WORK INSPECTION REQUEST (WIR) FORM

Contractor:	HAIF-FREYSSINET JV
Project:	RA2RC
Contract No.:	QPMO-410-CT-00618
Work Inspection Request Number:	QRXM114000-HFC-TEC-WIR-ITS-02-RO5-00098

Project Name: Package 3 - **Interim Road Access to Resort Core**	**Project Code:** QRXM114000
Location: 00	**Date:** 17-September-2025
Document Title: **Material Approval Request FOR ITS SYSTEM SUPPLYING & INSTALLING BY TRAFFIC TECH SECURITY W.L.L Red Light Camera System**	**Ref No:** QRXM114000-HFC-TEC-MAT-ITS-02-RO5-00006
	Rev No: 00

Drawing title:
SHOP DRAWING OF TRAFFIC SIGNAL SYSTEM FOR JUNCTION-3
TYPICAL ITS POLE DETAILS -
6.1M

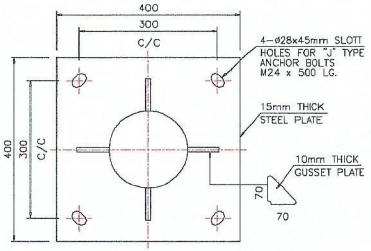
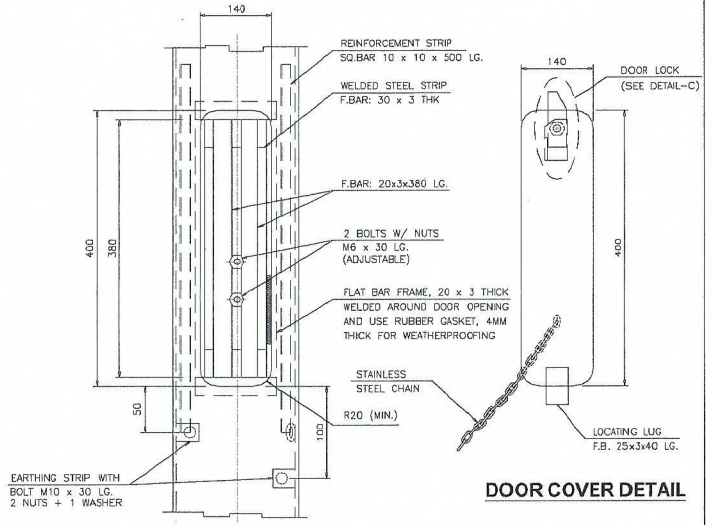
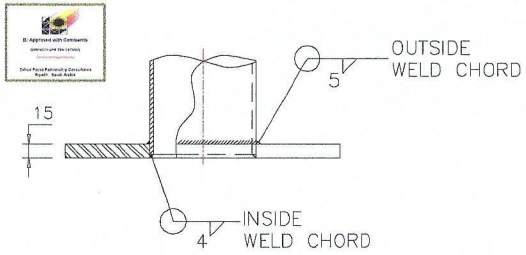
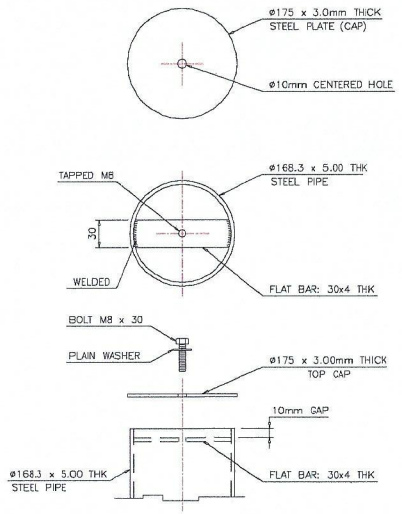
1.ITS poles shall be in accordance with the pole manufacturer's recommendations.
2. Galvanization & Compliance certificates with the standards to be provided
3. For other comments refer to drawing #QRXM114000-HFC-DRW-SDW-ITS-02-R05-00015

Drawing title:
SHOPDRAWING OF TRAFFIC SIGNAL SYSTEM FOR JUNCTION-2
TYPICAL ITS POLE DETAILS - 6.1M

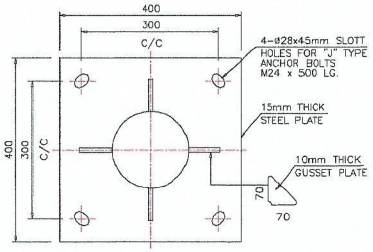
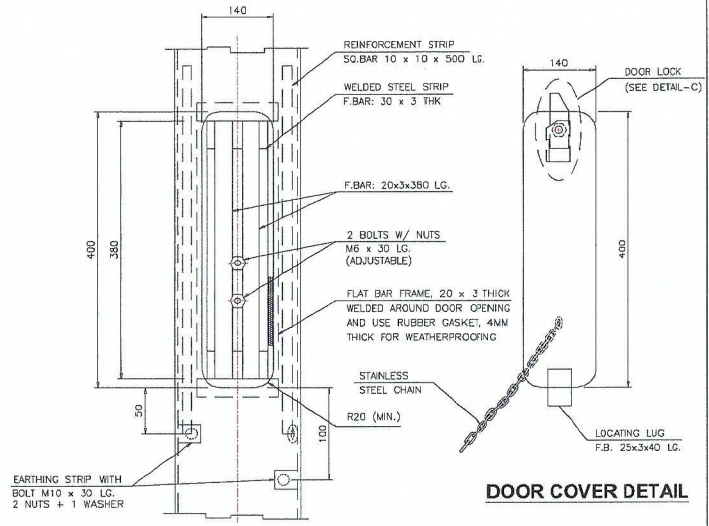
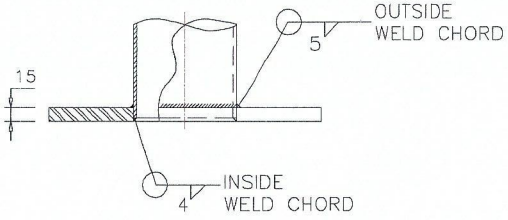
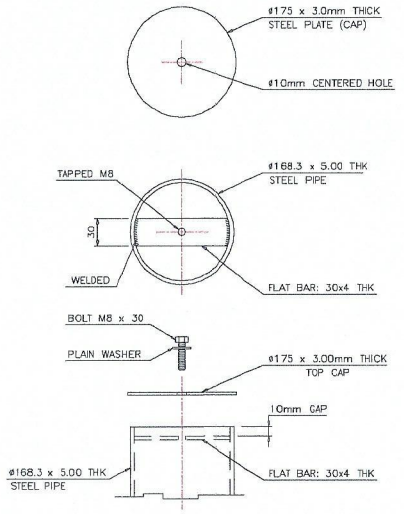
1. ITS poles shall be in accordance with the pole manufacturer's recommendations.
2. Galvanization & Compliance certificates with the standards to be provided.
3. For other comments refer to drawing #QRXM114000-HFC-DRW-SDW-ITS-02-R05-00024

Drawing title:
SHOPDRAWING OF TRAFFIC SIGNAL SYSTEM FOR JUNCTION-3
TYPICAL RISER DIAGRAM FOR LPR, RED LIGHT & CCTV CAMERAS

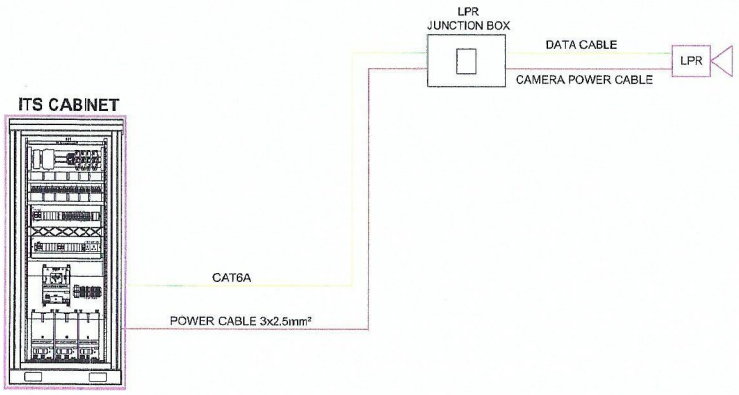
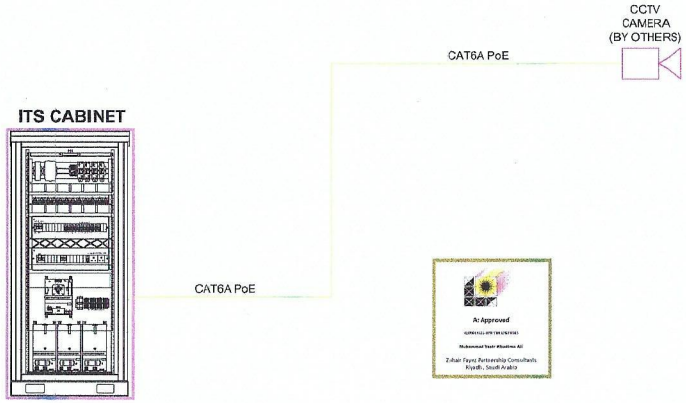
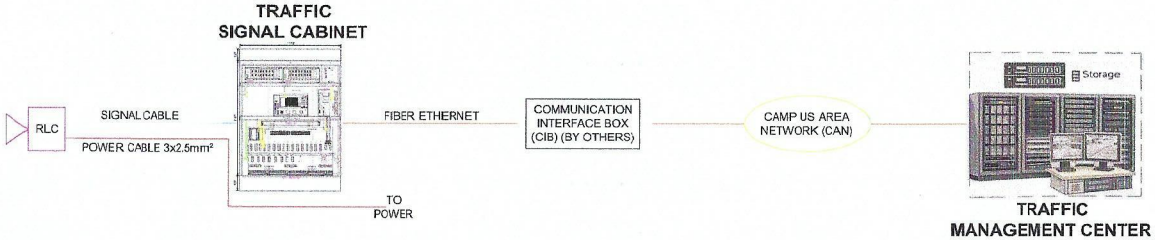
1.All the work/materials shall be in accordance with project specifications.
2.The storage size shall be sufficient to store data for the specified duration as mentioned in the project specifications.
3..The number of network switches in each ITS cabinet shall be based on the associated field device types.

Drawing title:
SHOPDRAWING OF TRAFFIC SIGNAL SYSTEM FOR JUNCTION-3
TYPICAL RISER DIAGRAM FOR LPR, RED LIGHT & CCTV CAMERAS

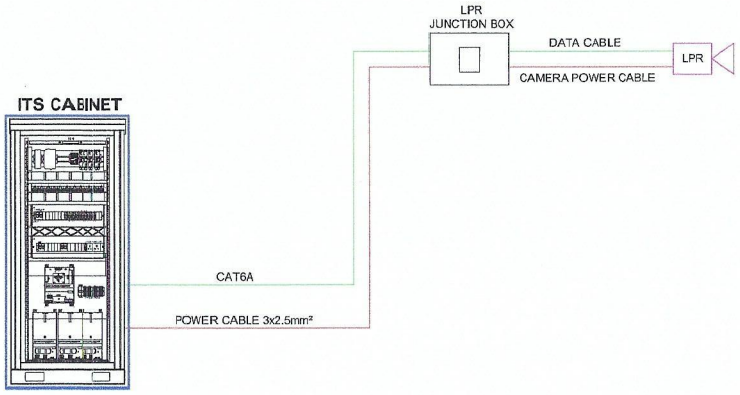
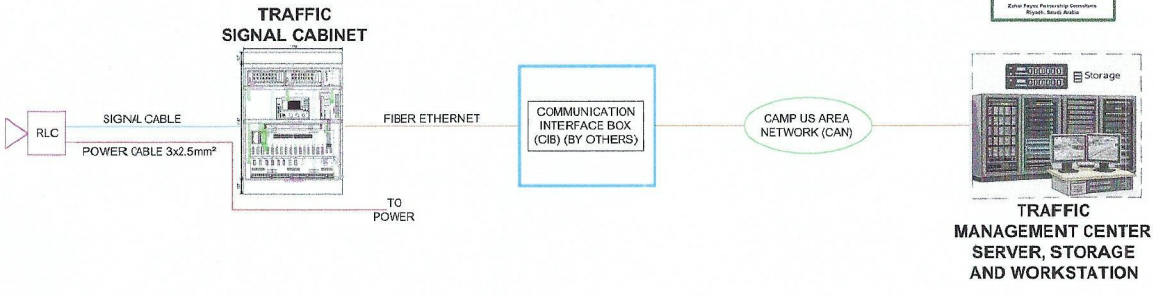
1.All the work/materials shall be in accordance with project specifications.
2.The storage size shall be sufficient to store data for the specified duration as mentioned in the project specifications.
3..The number of network switches in each ITS cabinet shall be based on the associated field device types.
